Serial: RNP-RA/04-0043

April 16, 2004

H. B. ROBINSON STEAM ELECTRIC PLANT, UNIT NO. 2
DOCKET NO. 50-261/LICENSE NO. DPR-23

RESPONSE TO REQUEST FOR ADDITIONAL INFORMATION
FOR RELIEF REQUEST PERTAINING TO EXAMINATION COVERAGE
LESS THAN ESSENTIALLY 100 PERCENT (RELIEF REQUEST NO. 34)

COMPONENT ID:	202/01	ASME CATEGORY:	C-A
ASME CODE FIGURE:	IWC-2500-1	ASME ITEM NUMBER:	C1.20
CONFIGURATION:	SHELL TO HEAD	% CRV ACHIEVED:	83.5%
PDI TECHNIQUE USED:	NO	EXAM DATE	4/27/01

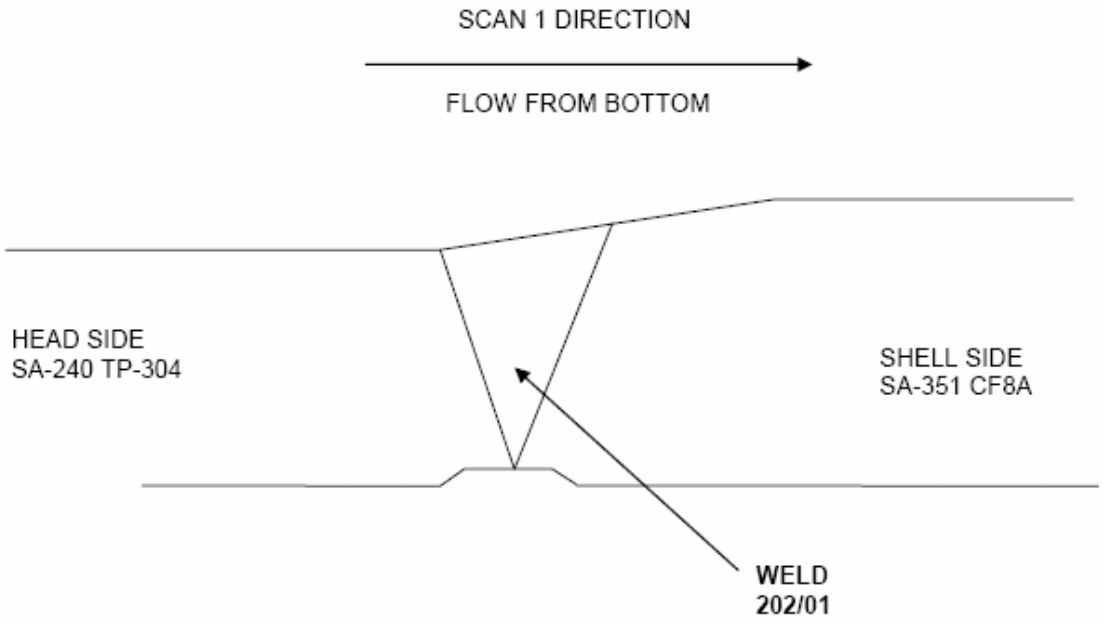
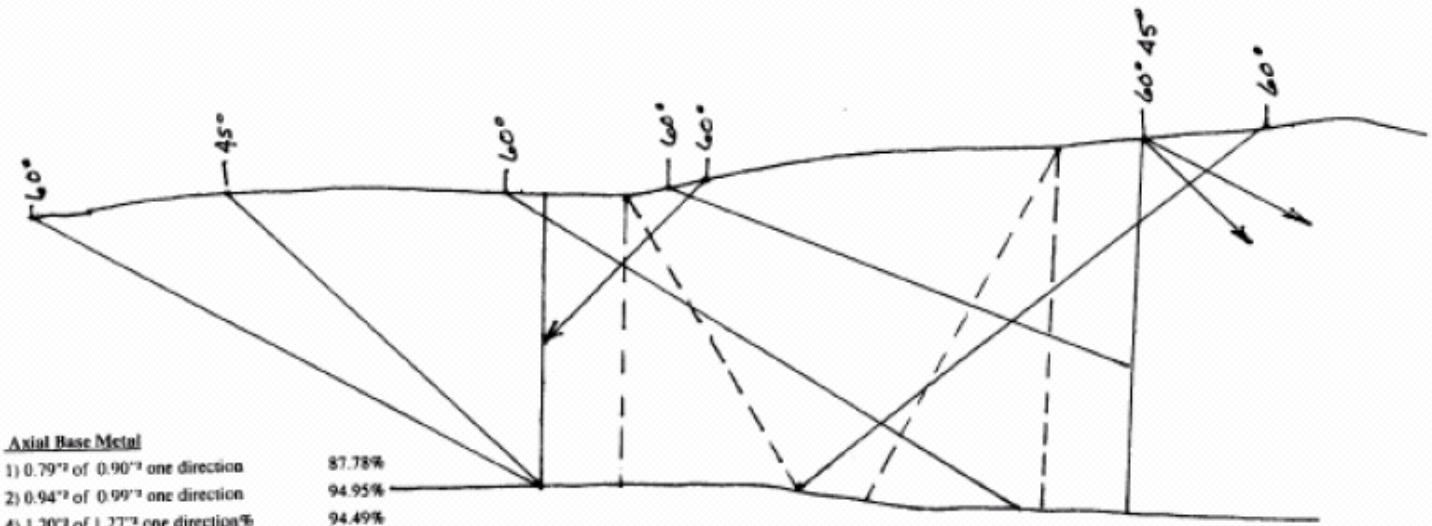
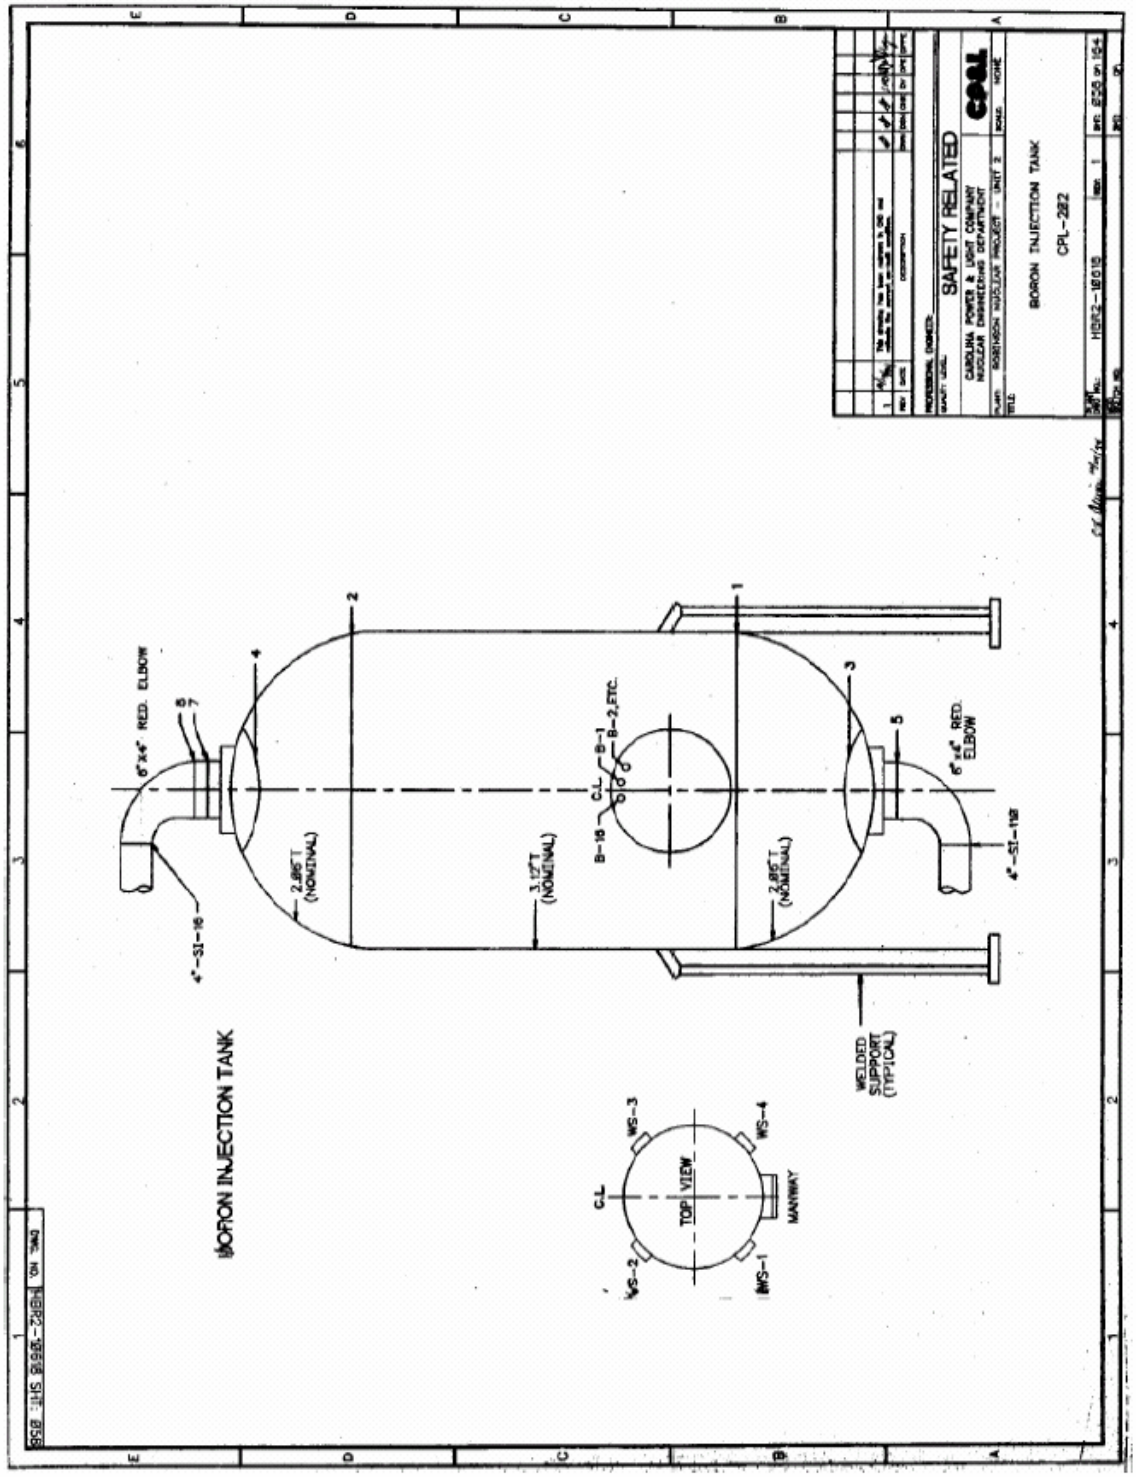
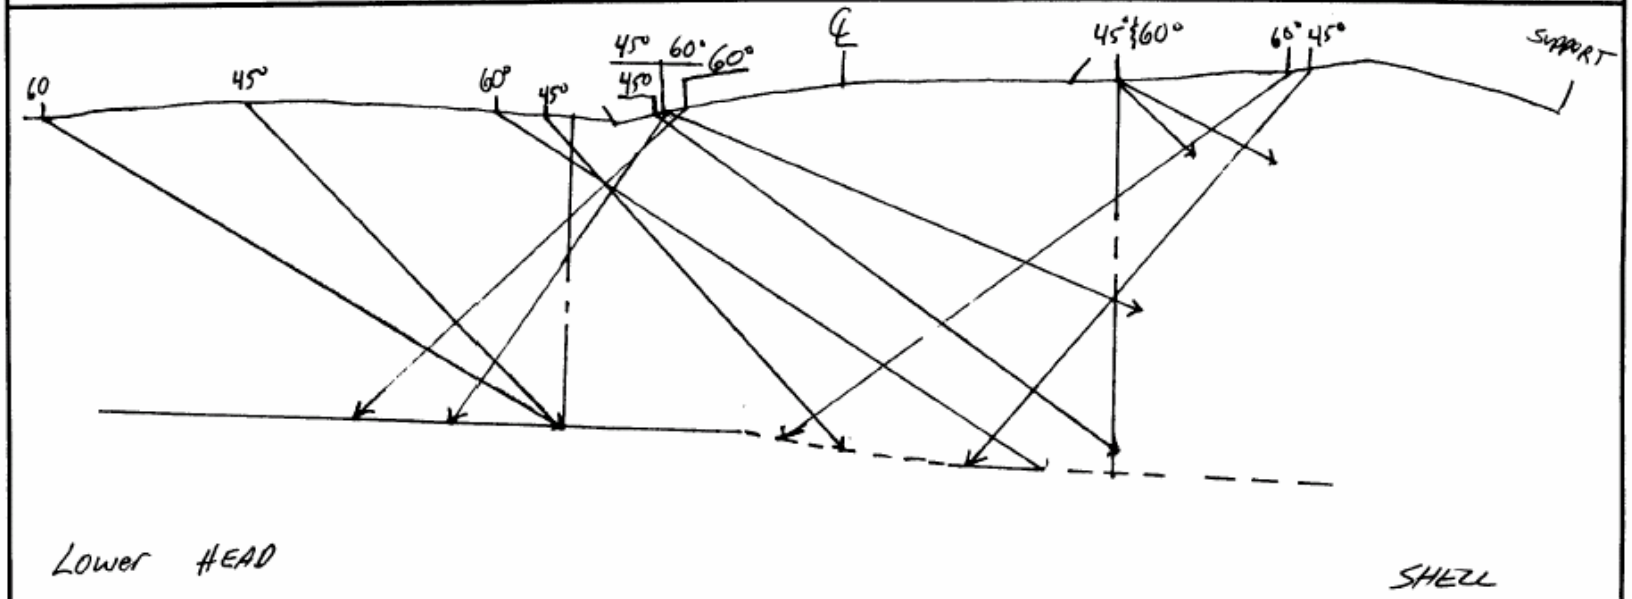
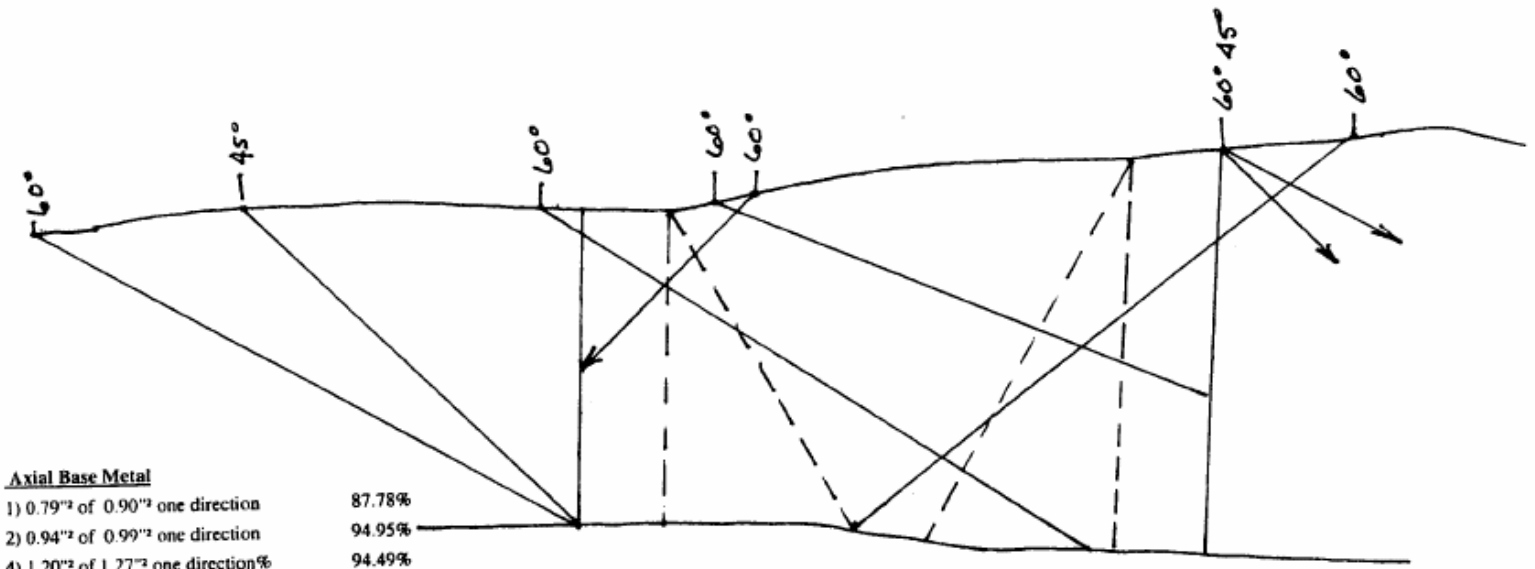
The welds listed in Table 2 of the current RAI identify three Category C-A and five Category C-F-1 welds. After further review, it has been determined that the three Category C-A welds were omitted inadvertently. The information requested by the previous RAI is provided for these welds in Attachment II to this letter.

$\frac{C1 + C2 + W1 + W2 + B1}{5}$ $\frac{417.43\%}{5}$

$\frac{100\% + 100\% + 37.97\% + 94.94\% + 84.52\%}{5}$ 83.49% Total Required Volume Achieved
